No	DESCRIPTION	DETAIL No.	MATERIAL	MATERIAL PATTERN No. OR DIMENSIONS	WT/LB
1	A.V.T. PANEL DETAILS	40090 - 1

Redrawn Jan 2002
Chris Colebrook

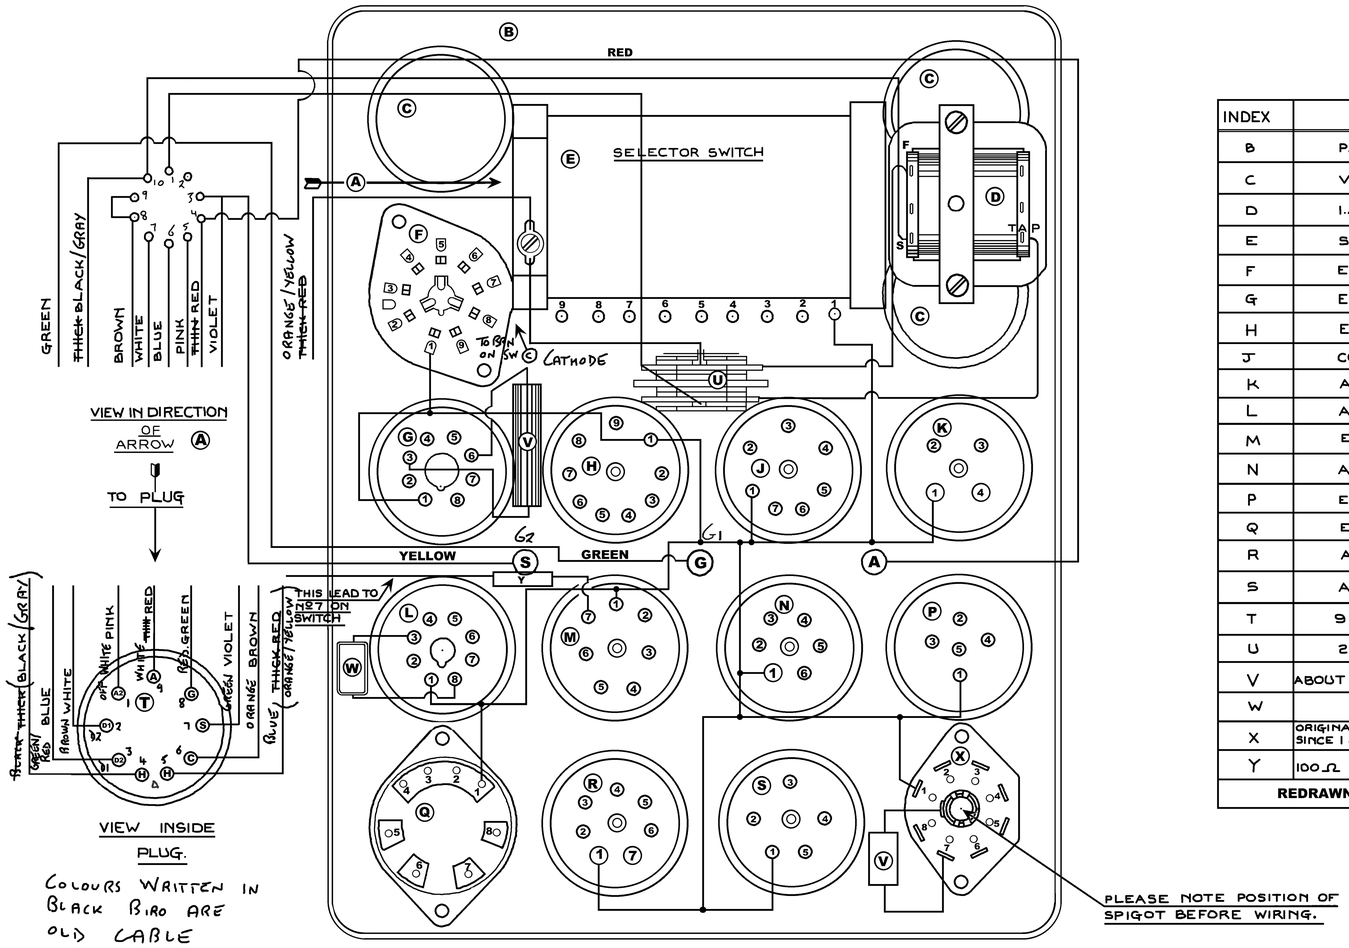
1. A2 Pink
2. D2 White
3. D1 Blue
4. H Black/Gray
5. H Orange/Yellow
6. C Brown
7. S Violet
8. G Light Green
9. A Red

Above colours for new cable, and 9 pin plug.

Ref D1 & D2 A.V.O. appear to have them reversed.

Colours written in black biro are old cable colours in brackets new cable.

Colours printed on blueprint are A.V.O's colours. New cable matched to these except heaters
